**Report of the informal correspondence group on burning
rate: Amendments to subsection 51.4 of the Manual of Tests
and Criteria**

**Transmitted by the expert from China on behalf of the informal
correspondence group**

This document contains the text of section 51 of the Manual of Tests and Criteria with the amendments proposed by the informal correspondence group listed in document ST/SG/AC.10/C.3/2024/41 – ST/SG/AC.10/C.3/2024/7.

All changes are indicated: deleted text appears in ~~striketrough~~ and new text in **bold underlined**.

Figure 51.4.1: Measurement of radiation as a function of time

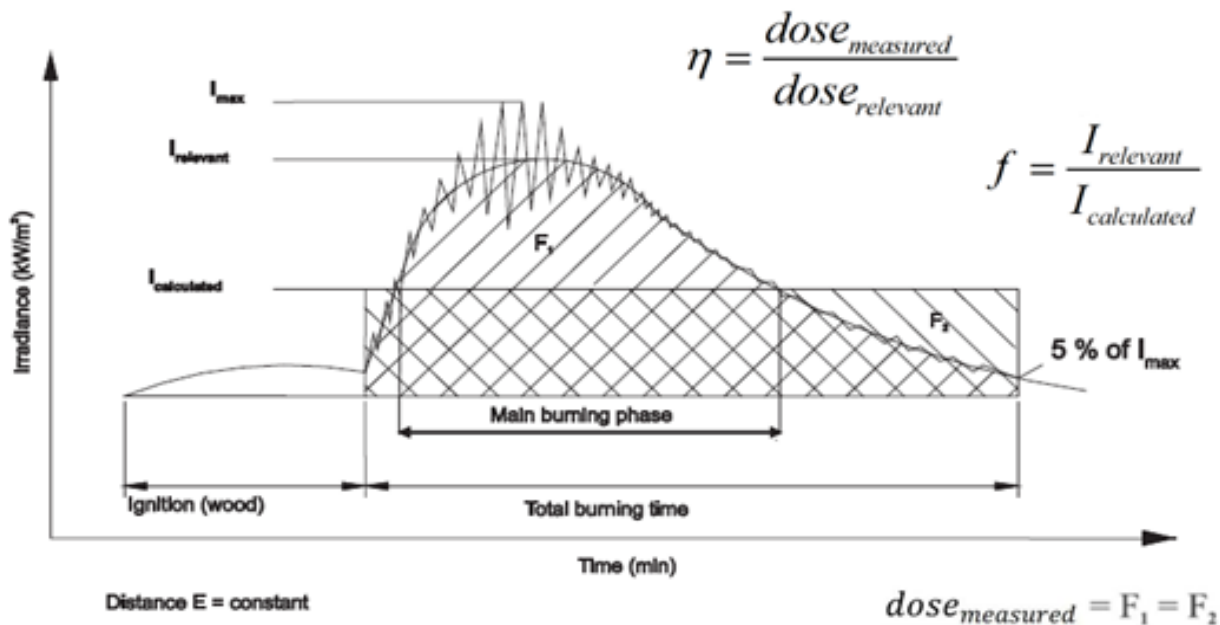
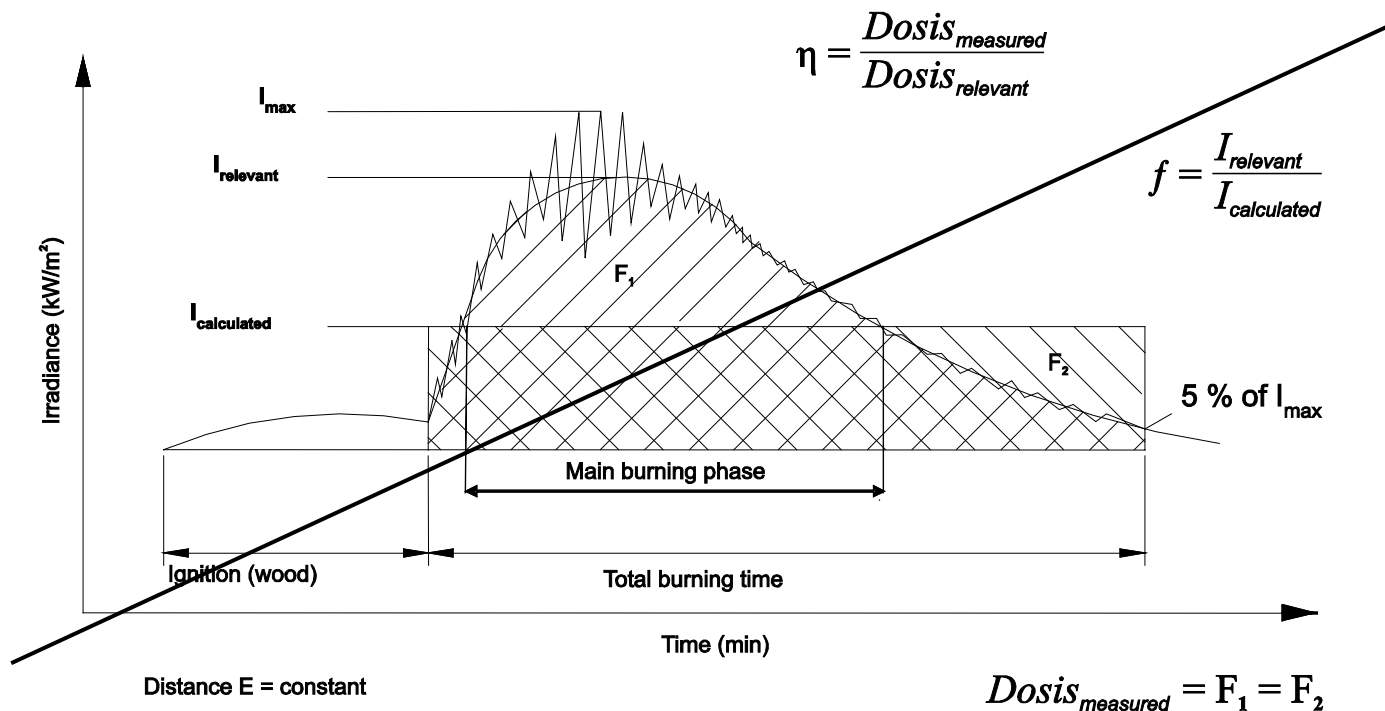
- (a) The starting point of the fire is defined as the moment at which the substance or mixture reacts detectably. The end **point** of the fire is characterized by a decrease in **irradiance radiation level** I (as caused by the fire) to less than 5 % of the maximum **level irradiance** (I_{max}). **The maximum irradiance (I_{max}) is an average of the irradiance measured over a period of at least 30s during the period of peak thermal radiation. The total burning time t is the time span between the starting point and the end point of the fire** (see figure 51.4.1);

- (d) To this end a graph is made showing the ~~radiation level~~ **irradiance** I [kW/m²] as a function of time. The complete radiation dose is calculated by integration of the smoothed and corrected curve down to 1 % to 5 % of I_{max} ;
- (e) $I_{relevant}$ is obtained from the maximum of the **smoothed and corrected** curve of **the measured** heat radiation. ~~$I_{calculated}$ calculated~~ **is the** as average value of the radiation **obtained** by converting the integrated area in a rectangle of equal size during the same **total burning** time span **(see figure 51.4.1)**;
- (f) The form factor f that must be taken into account during the maximum fire intensity can be averaged from the formula:
